21-VARIANCE-0011, 21-WAIVER-0016 & 21-WAIVER-0017 Scooters Coffee Shelbyville Road Variance and Waivers

Louisville Metro Board of Zoning Adjustment Public Hearing Rachel Mandell, Planner I March 15th, 2021

Site Plan

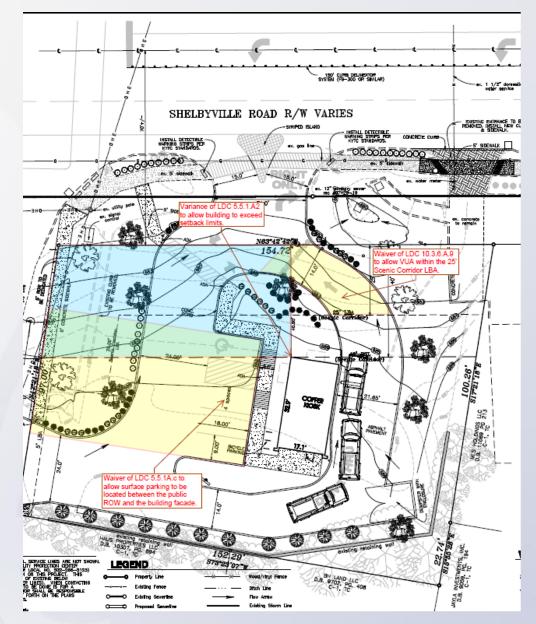
- Staff finds that the requested variance to exceed the maximum setback meets the standard of review.
- Staff finds that the requested waiver to allow surface parking between the front façade and public right of way meets the standard of review.
- Staff finds that the requested waiver to encroach into the scenic corridor buffer area meets standard of review c, but does not meet standards a, b and d.
